## **Central Planning Authority**

**Minutes** of a meeting of the Central Planning Authority held on November 11, 2020 at **10:00am, in Conference Room 1038, 1<sup>st</sup> Floor, Government Administration Building, Elgin Avenue and via Zoom e-meeting.**

**CPA/19/20**

Application for a hotel (10 storeys), conference facility and modifications to an existing hotel. The application includes the following elements:

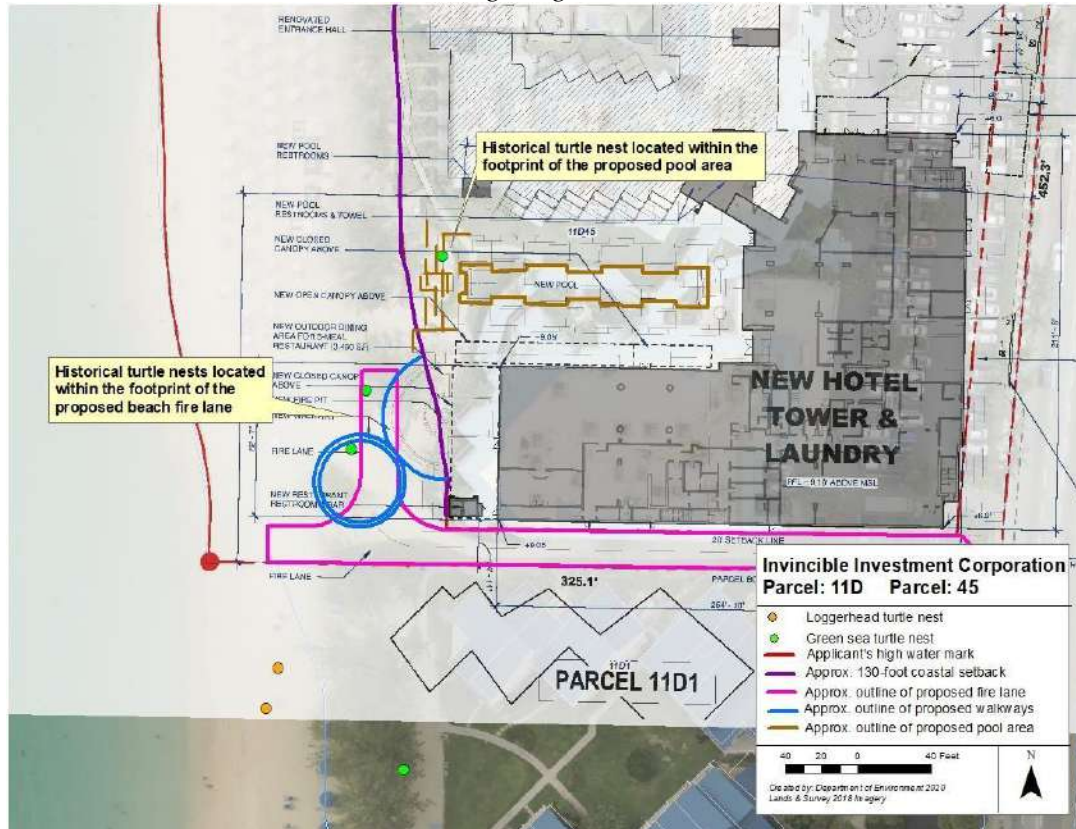
The Applicant has not requested any variances to the Development and Planning Regulations coastal setbacks, however, as shown in Figure 1, portions of the proposed pool deck, the proposed outdoor seating area, walkways and the proposed fire lane are all located within the 130-foot setback from the Mean High Water Mark. These areas of the proposed development also have historical turtle nests located within their footprints. Hard structures located within the 130-foot setback i.e. the fire lane on the beach, decrease the size of the potential turtle nesting habitat.

The DoE strongly maintains its stance that coastal setbacks should not be reduced but instead should be treated as a minimum (as prescribed in the Planning Regulations) as setbacks seek to protect properties against the inevitable effects of climate change such as coastal flooding and erosion by ensuring that hard structures are not located in an area susceptible to these hazards.

*The maintenance of coastal setbacks is imperative for the long-term health of beaches. Given climate change predictions for the region, including sea-level rise and increased intensity of storm events (including storm surge) inappropriately sited development (either on the active beach or too close to the Mean High Water Mark) reduces a beach's potential to recover after major events. This "squeezing" of the beach caused by inappropriately sited development and climate-change induced storms and inundation may reduce the potential area that serves as turtle nesting habitat. For this reason, the Department **does not** support a coastal setback variance and recommends that all hard structures including pool deck, walkways and the fire lane are redesigned to meet the minimum 130-foot coastal setback rather than encroaching on the nesting beach.*

**Figure 14: Digital Terrain Model (DTM) for the application site. The higher areas of the site are indicated in red and orange and show the beach ridge and sand reserves**

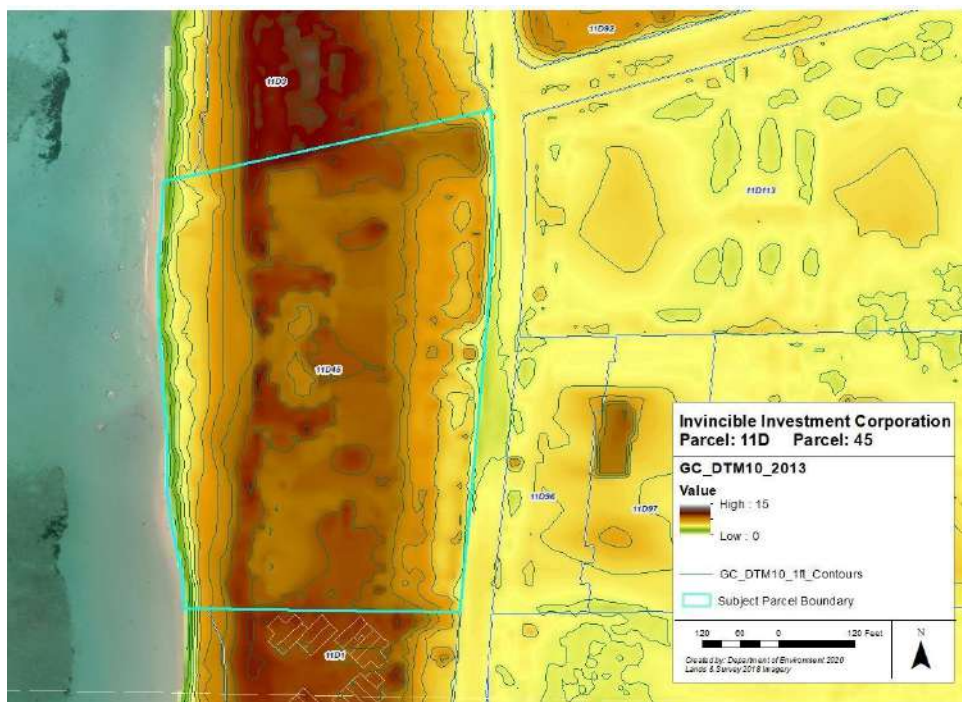
*Although the subject parcel is predominately man-modified, it still consists of massive sand reserves as shown in Figure 14 and the removal of these reserves is a concern. The reserves are important to the resilience of the beach system and are a natural source of sand which replenishes the beach profile after major storms. A significant amount of sand may result from the excavation for the foundations and pool. Once excavated and removed from the beach system, these sand reserves can never be recovered, making the beach system increasingly more vulnerable to erosion, which is exacerbated by the impacts of climate change, especially sea-level rise. We recommend that any excavated sand is kept on-site and placed landward of the High-Water Mark to retain sand reserves and create depth in the beach profile.*

*With the demolition of the southern single-storey building and the construction of a 10-storey hotel tower in its place, even if repositioned to comply with the minimum required setback under the Development and Planning Regulations, it will be visually prominent on the beach. When the proposed 10-storey hotel tower is constructed it may block daylight, sunlight and views from the northern units of the neighbouring residential property to the south (Villas of the Galleon) (see Figure 15).*

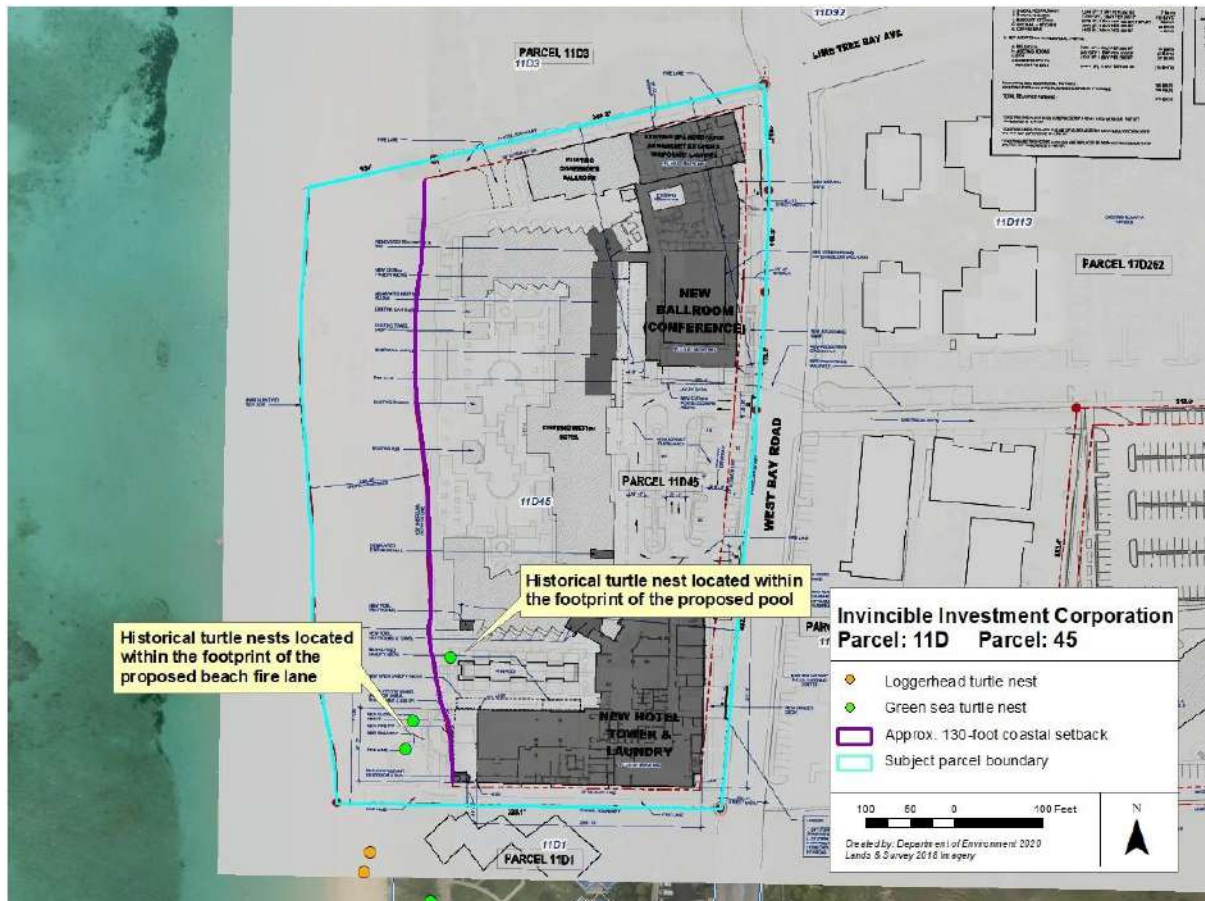
The Applicant has not requested any variances to the Development and Planning Regulations coastal setbacks, however, as shown in Figure 2, portions of the proposed pool deck, the proposed outdoor seating area and the proposed fire lane are all located within the 130-foot setback from the Mean High Water Mark. These areas of the proposed development also have historical turtle nests located within their footprints. Hard structures located within the 130-foot setback e.g. the fire lane on the beach, decrease the size of the potential turtle nesting habitat.

The Applicant has not provided a Landscaping Plan with this proposal. Current landscaping on-site consists of non- native landscaping plants and invasive casuarina trees. The Applicant could include the use of native vegetation in new landscaping associated with the proposed development.

- The applicant shall prepare and submit a plan to the Department of Environment for turtle friendly lighting, which minimises the impacts on sea turtles. All lighting shall be installed in accordance with the plan, to be approved by the DoE. Guidance on developing a lighting plan can be found in the DoE's Turtle Friendly Lighting: Technical Advice Note (September 2018).*

**Figure 1: LIS 2018 imagery showing historical turtle nests on the critical nesting beach as well as the primary vegetation located on the site. The green dots indicate historical green turtle nests and the orange dots indicate historical loggerhead turtle nests.**

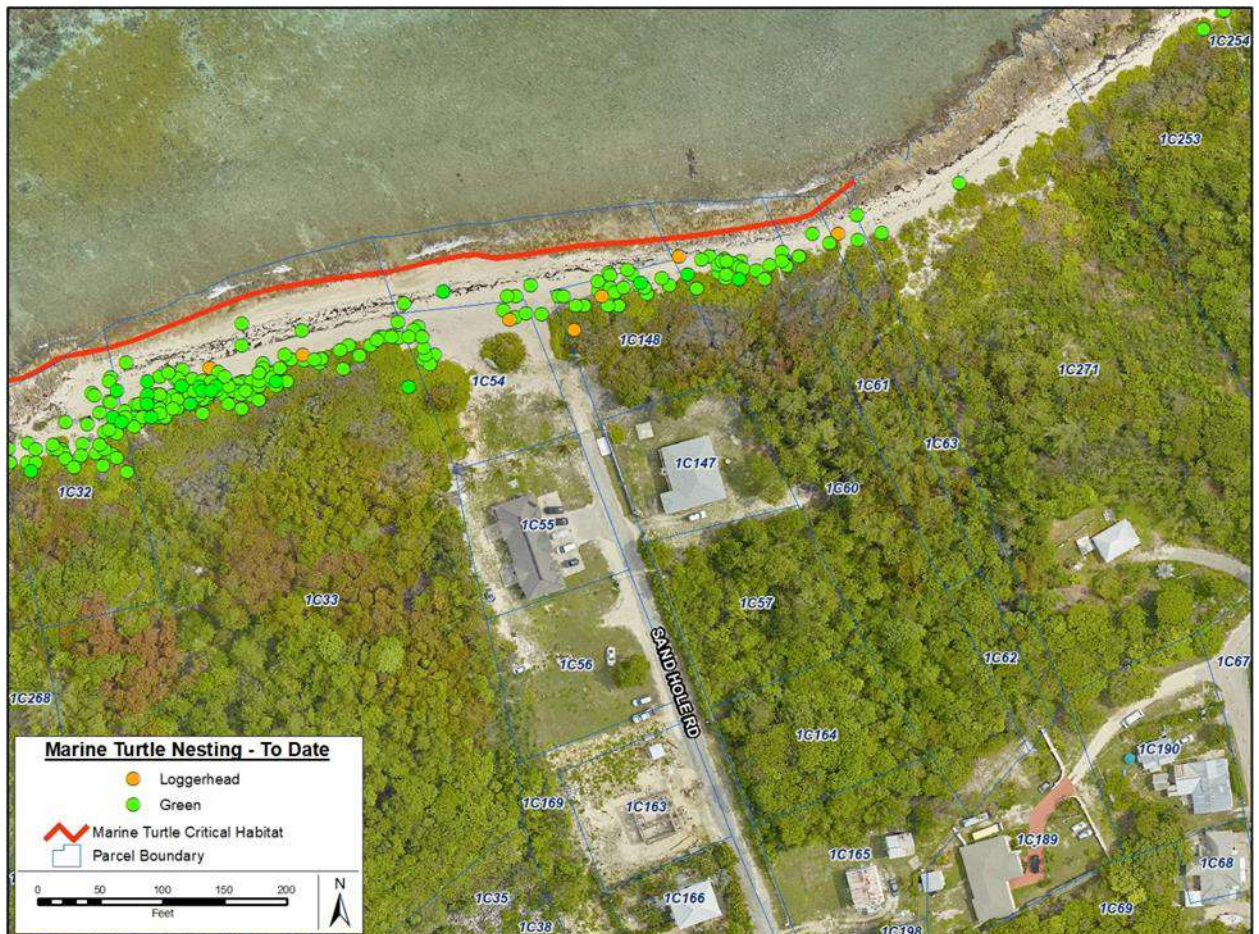
*The below sub-sections detail the potential impacts of the proposed development on the critical nesting beach.*

*In accordance with section 41(5)(a) of the National Conservation Law, the Department directs the use of turtle friendly lighting on this development site. Figures 2-4 provide examples of other properties in Grand Cayman that have turtle friendly lighting installed.*
